EPC STORMWATER REVIEW COMMENTS  
IN ORANGE BOXES WITH BLACK TEXT

**PRELIMINARY DRAINAGE REPORT  
FOR  
TRIPLE H RANCH - PRELIMINARY PLAN  
AND  
FINAL DRAINAGE REPORT FOR EARLY GRADING  
(TEMP. ACCESS ROAD AND TANK/WELL SITE)**

**CCES  
RESPONSES**

PCD Project No. SP 254

TRIPLE H RANCH - PRELIM. PLAN  
PRELIMINARY DRAINAGE REPORT  
PRE-DEVELOPED CONDITIONS  
2604.00  
SHEET 1 OF 2

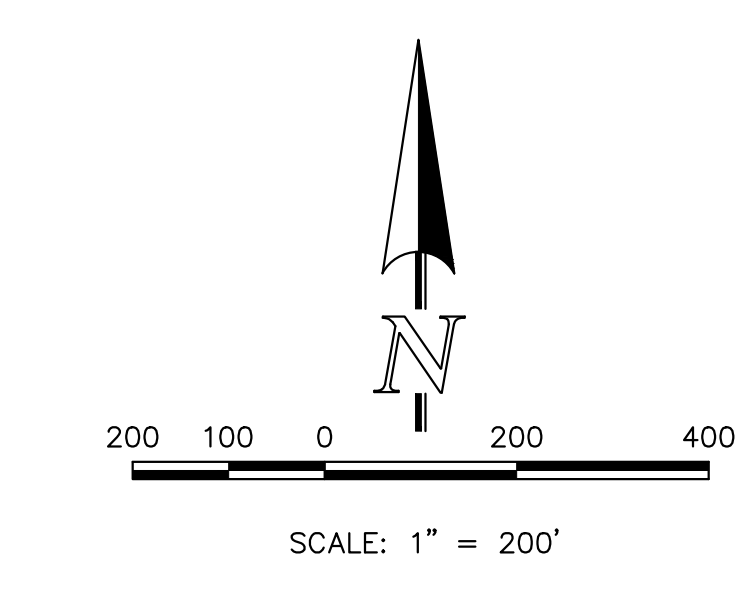
Provide drainage map for interim/early grading condition (Shows access road and grading for tank site, TSB's, as well as any grading/creeks needed to route flows to TSB's and through site.)

**BNDY. LINE IS THE DARK BLACK LINE WITH BASIN LINE ON IT. FLOWS CONTINUE TO SHEET FLOW OFF-SITE ALONG EAST BNDY.**

**AS DISCUSSED WITH ENGINEERING AND SW, WE HAVE NOW REMOVED THE EARLY GEC PLAN REQUEST**

TRIPLE H RANCH  
PRELIMINARY DRAINAGE REPORT  
DEVELOPED CONDITIONS  
2604.00  
SHEET 2 OF 2

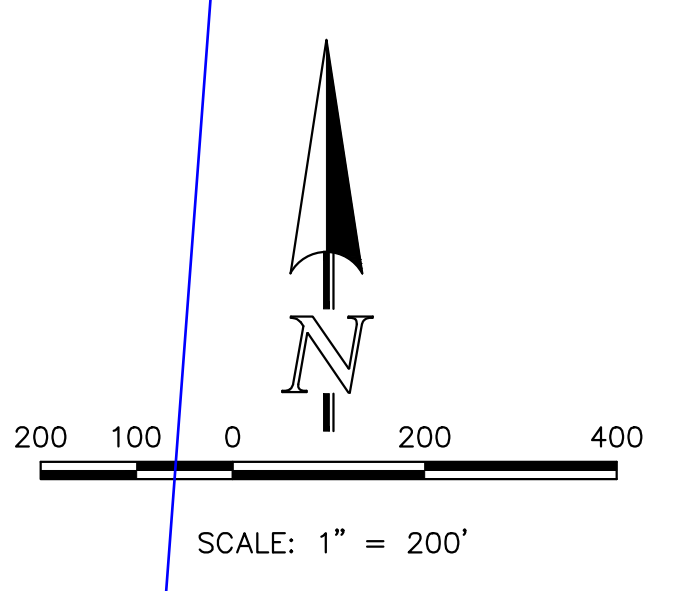
Map will be reviewed in more detail once proposed hydrology calculations have been provided with next submittal.

Provide basin summary table

Provide Design Point table with flow values
